**PROPOSITION 39
ENERGY EFFICIENCY UPGRADES
EEP3**

**PHASE 2 & PHASE 3
ADDENDUM 05**

To: All bidders
From: John Fisher, AIA, Principal
Project: SBCUSD Proposition 39 Energy Efficiency Upgrades EEP3
Phase 2 & Phase 3- Energy Upgrades
Date: February 26, 2019

3. Bid Package # 1 (Phase 2) – HVAC Cajon High School - Revisions
Sheet G0-02, M1-02 & M1-11, Delta 1 Revision per DSA comments.

Drawing No: M 1-02

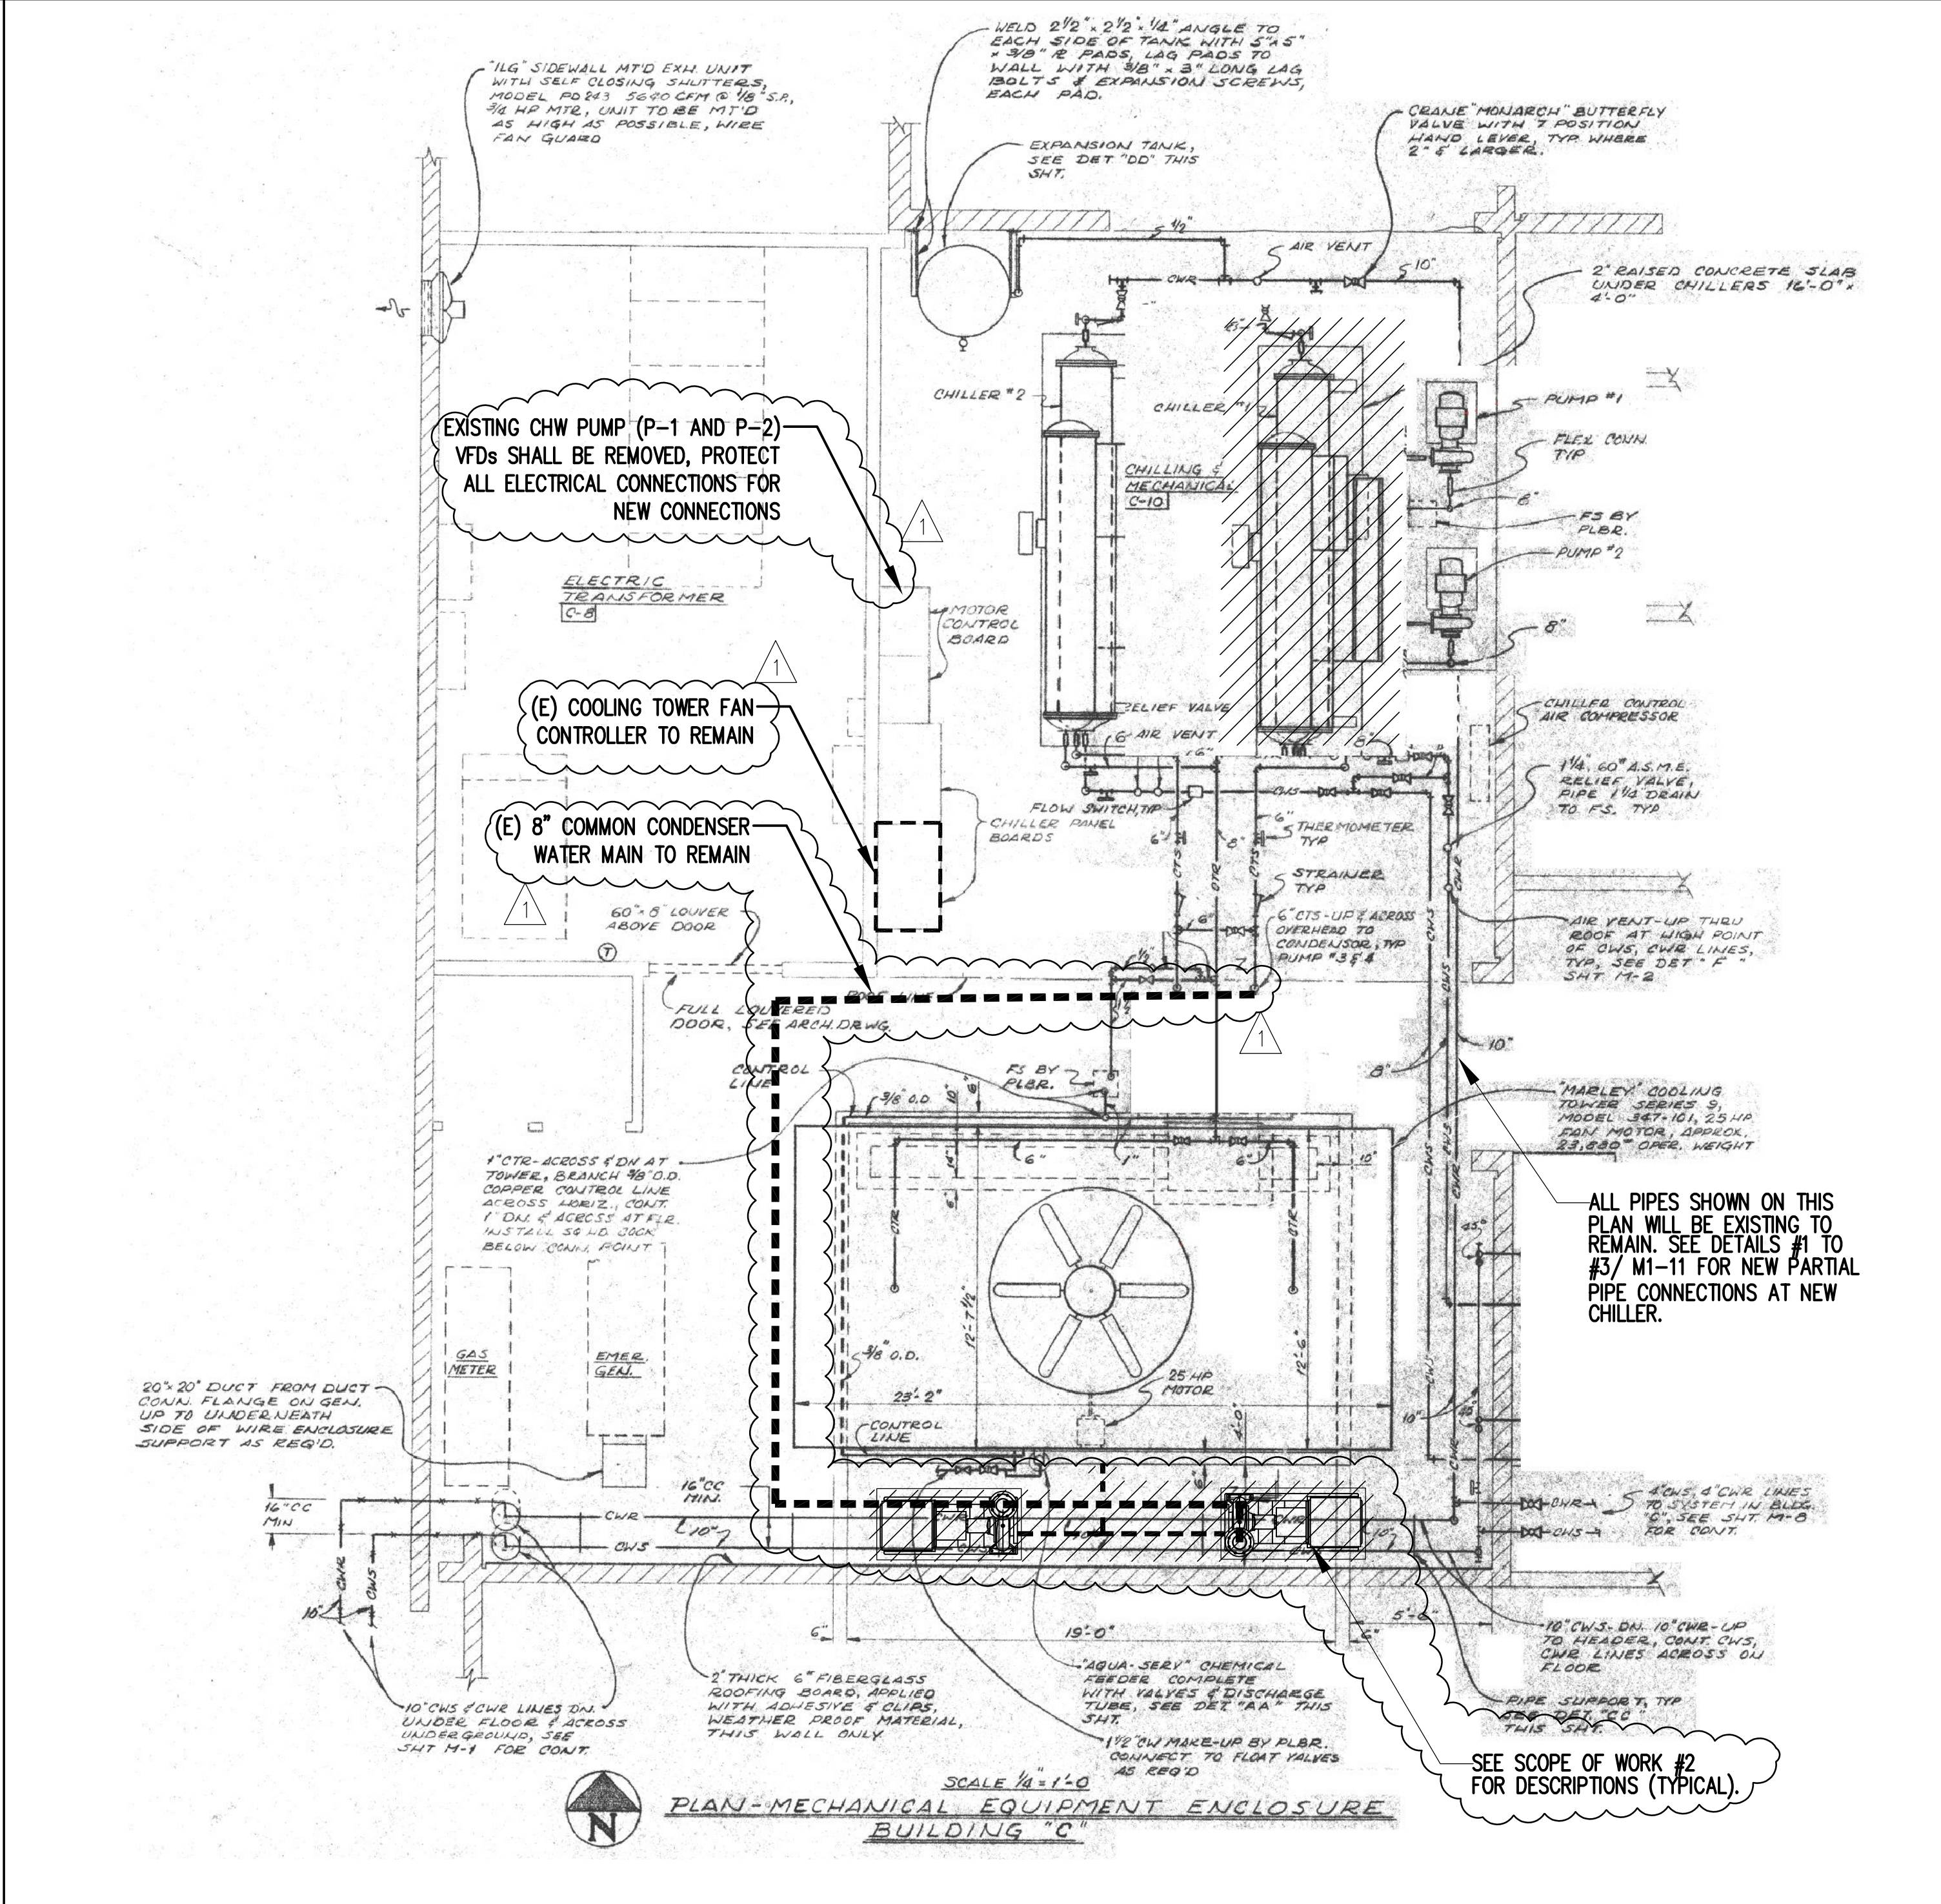
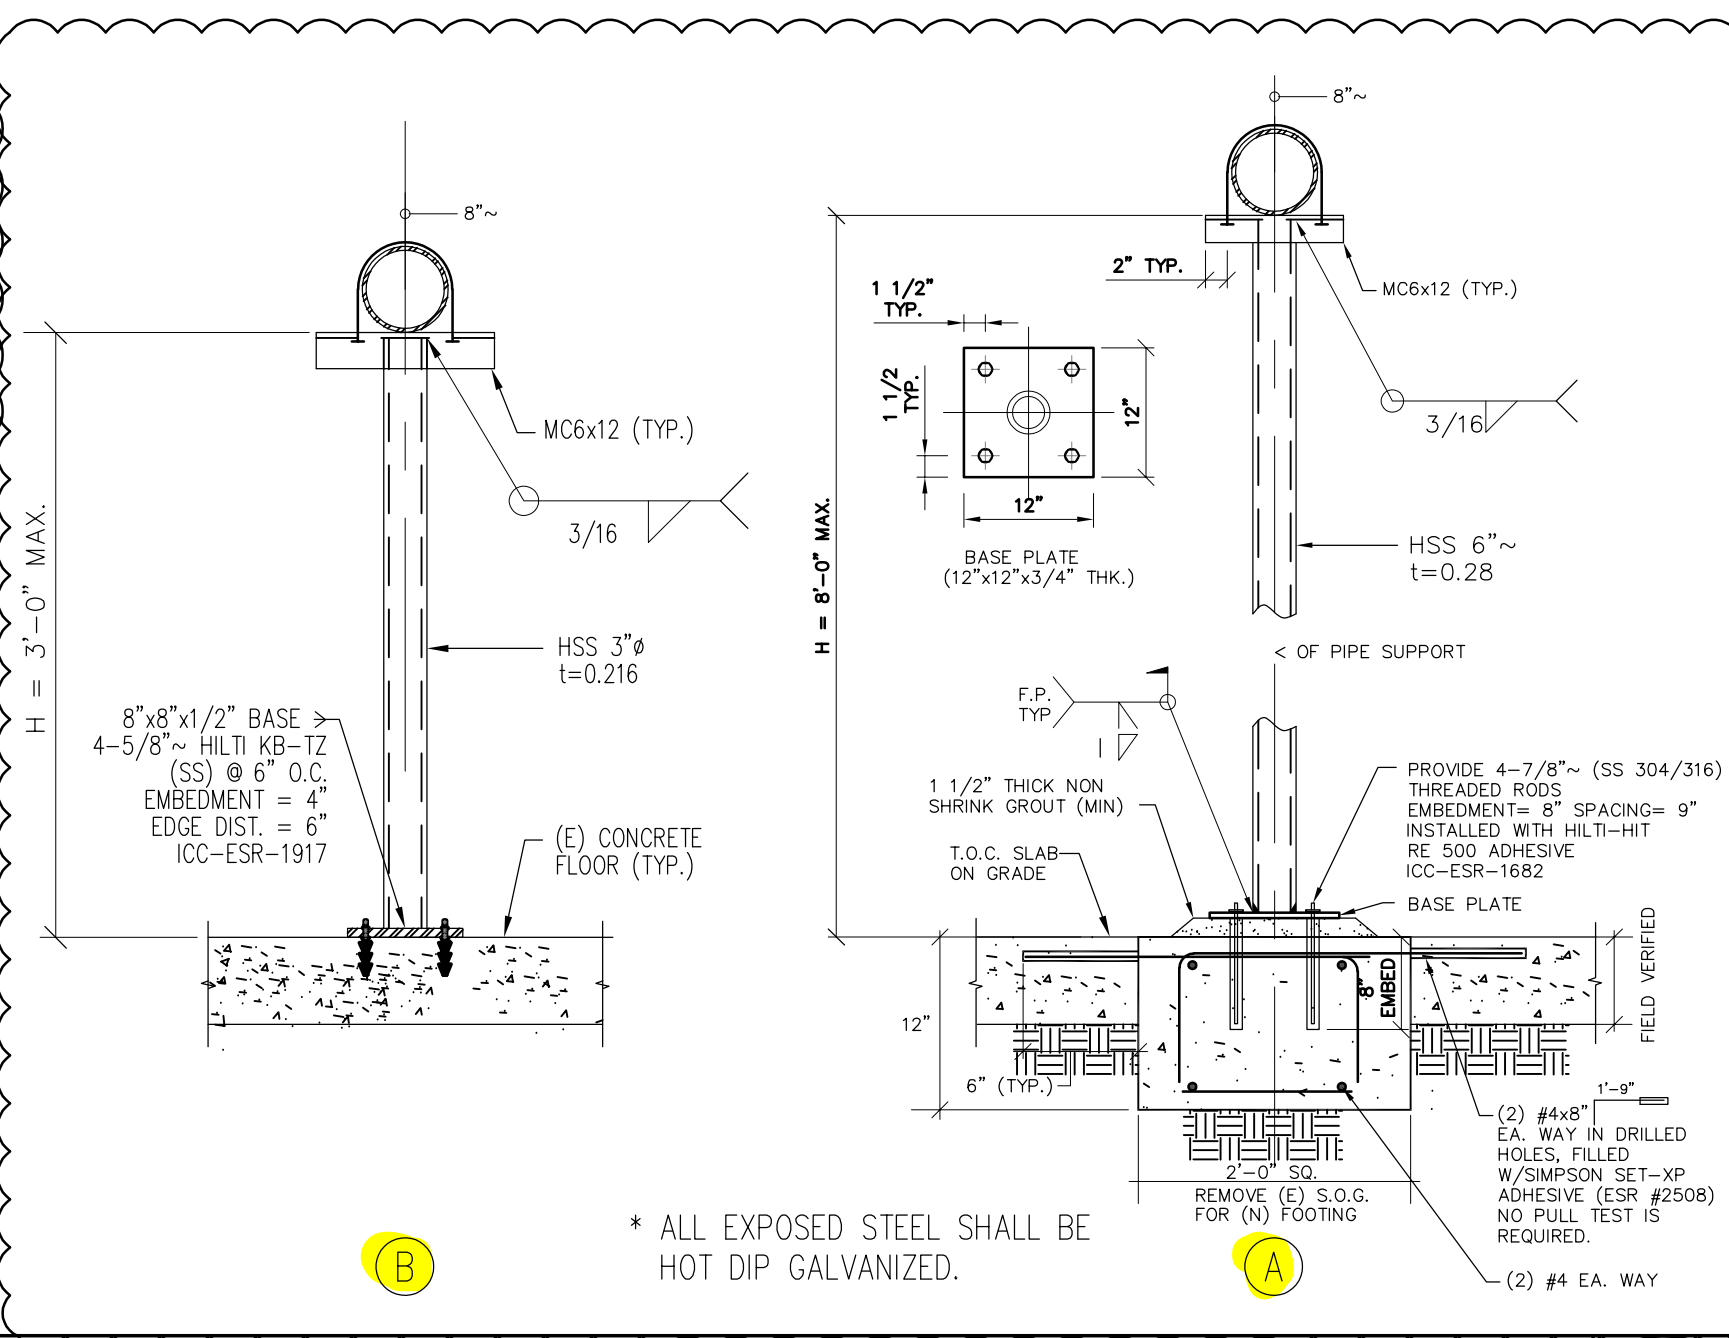
- SCOPE OF WORK:**
1. REMOVE (E) WATER COOLED CHILLER AND ASSOCIATED CONCRETE PAD.
 2. REMOVE (E) CONDENSER WATER PUMPS, ASSOCIATED SUCTION DIFFUSERS, CONCRETE PAD, ANCHORAGE, AND PARTIAL PIPING UP TO COOLING TOWER SUPPLY MAIN AND PARTIAL DISCHARGE PIPING UP TO THE EXISTING BRANCH ELBOW AFTER THE TRIPLE DUTY VALVE. EXISTING TRIPLE DUTY VALVE AND FLEX CONNECTOR SHALL BE TEMPORARY REMOVED, PROTECTED AND REUSE FOR NEW INSTALLATION. FLEX CONNECTORS AND ELECTRICAL WIRING & CONDUIT SHALL BE REMAINED, PROTECTED AND REUSED.
